## Informal meeting on Code of Practice for Packing of Cargo Transport Units

## Dunnage bags

### Submitted by the Russian Federation

This document proposes addition to the Appendix 4 of Annex 7, section 4 on Cargo securing with dunnage bags. The proposed new text is marked in red.

##### 4.2 Force on dunnage bag from cargo ( $F_{\text{CARGO}}$ )

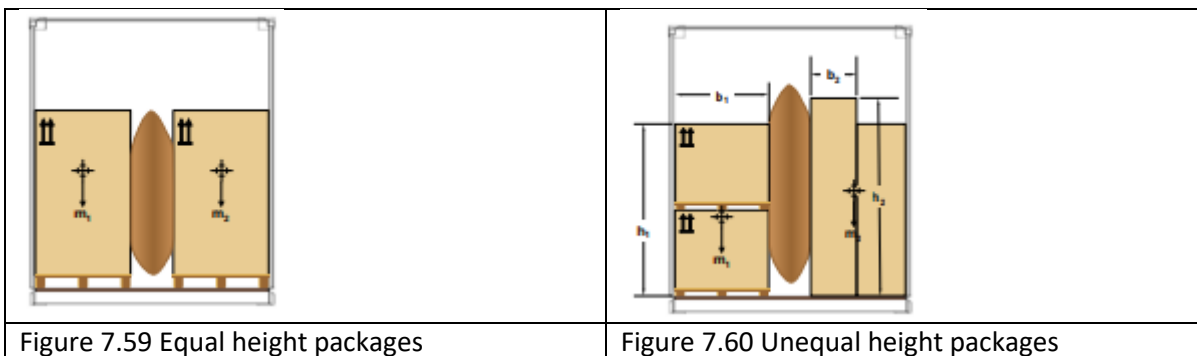
4.2.3 Only the cargo mass that actually **impacts-acts on** the dunnage bag that should be used in the above formulas. If the dunnage bag is used to prevent movement forwards, when braking for example, the mass of the cargo behind the dunnage bag should be used in the formulas.

4.2.4 If the dunnage bag instead is used to prevent movement sideways, the largest total mass of the cargo that either is on the right or left side of the dunnage bag should be used, that is, either the mass  $m_1$  or  $m_2$  (see figure 7.59).

4.2.7 However, in both cases the total mass of the cargo that is on the same side of the dunnage bag should be used, that is, either the mass  $m_1$  or  $m_2$  in figure 7.60.
